Project	IEEE 802.16 Broadband Wireless Access Working Group < http://ieee802.org/16 >	
Title	CBC Mode and Initial Vector for the AES algorithm	
Data Submitted	2005-03-09	
Source(s)	Sungcheol Chang Jaesun Cha Seokheon Cho Chulsik Yoon ETRI 161, Gajeong-dong, Yuseong-Gu, Daejeon, 305-350, Korea	Voice: +82-42-860-5456 Fax: +82-42-861-1966 scchang@etri.re.kr chosh@etri.re.kr jscha@etri.re.kr
Re:	This is a response to Sponsor Ballot 16e on P802.16e/D6..	
Abstract	The document contains suggestions on the changes in IEEE P802.16e-D6 that would support new encryption mode and efficient way to give a random initial value of it.	
Purpose	The document is submitted for review by 802.16 Working Group members.	
Notice	This document has been prepared to assist IEEE 802.16. It is offered as a basis for discussion and is not binding on the contributing individual(s) or organization(s). The material in this document is subject to change in form and content after further study. The contributor(s) reserve(s) the right to add, amend or withdraw material contained herein.

CBC Mode and Initial Vector for the AES algorithm
Sungcheol Chang, Jaesun Cha, Seokheon Cho and Chulsik Yoon
 ETRI

Proposed changes

Figure xxx – CBC IV generation.

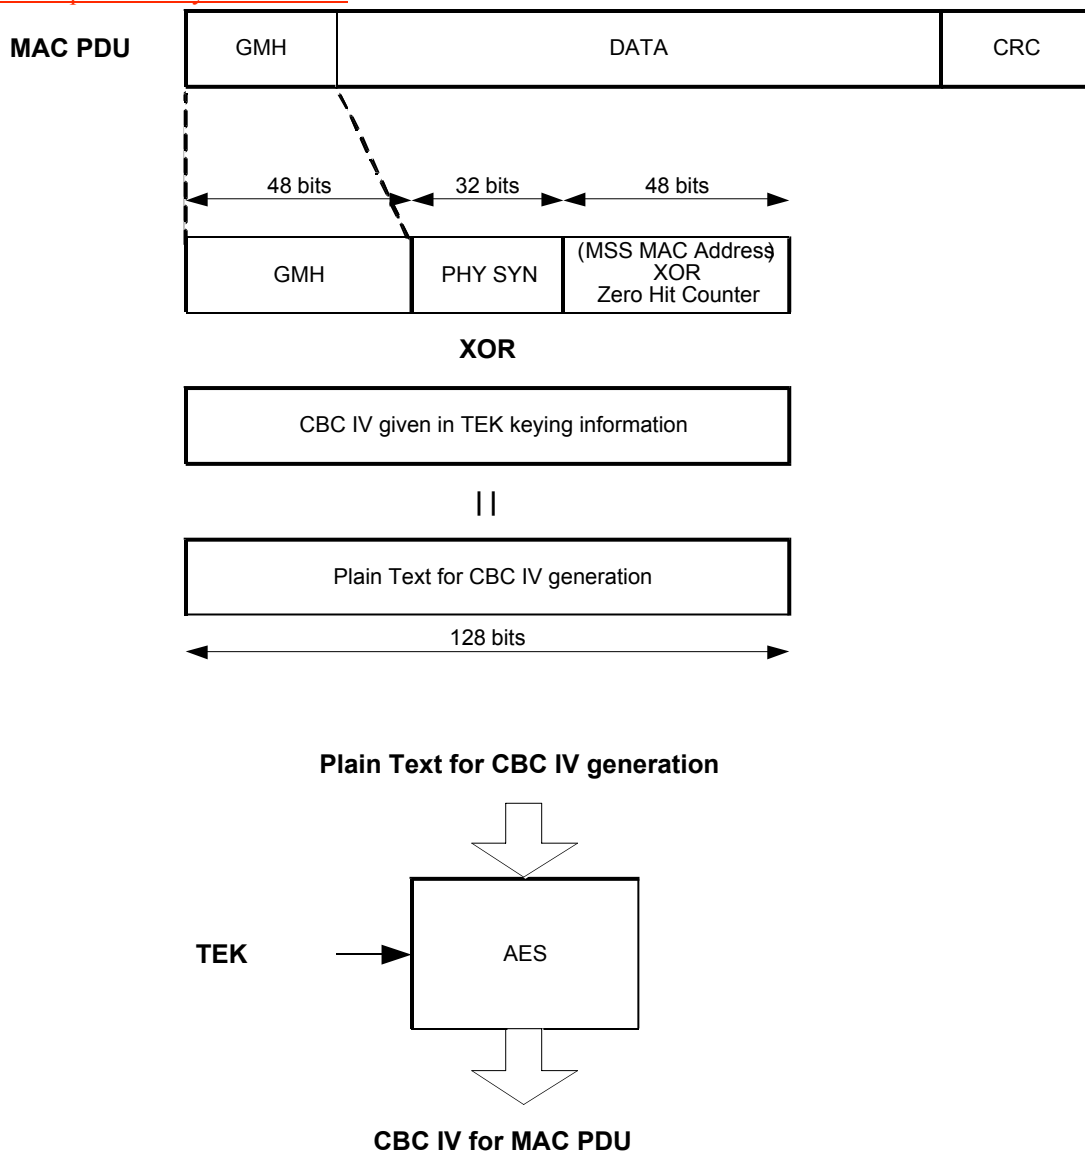
7.8.4.3.1 CBC IV generation

The Zero Hit Counter is initialized into zero when the Key Reply message is received, and updates whenever either the PHY Frame number is zero or MAC PDU is received in a frame. The Zero Hit Counter increases by one if the previous PHY Frame number is equal to or greater than the current PHY Frame number.

The CBC IV is generated as the result of the AES block ciphering algorithm with the key of TEK. Its plain text for the CBC IV generation is calculated with the exclusive-or (XOR) of (1) the CBC IV parameter value included in the TEK keying information, and (2) the 128-bits content which is a concatenation of the 48-bit MAC PDU Header, the 32-bit PHY Synchronization value of the MAP that a data transmission occurs, and the XOR value of the 48-bit MSS MAC address and the Zero Hit Counter.

The CBC IV shall be updated every MAC PDUs.

If the MAC PDU is decoded from several channel coded blocks transmitted at different frames in HARQ operation, the MAC PDU payload must be decrypted with the CBC IV value which are generated from the PHY Synchronization value of the MAP when spid=0.
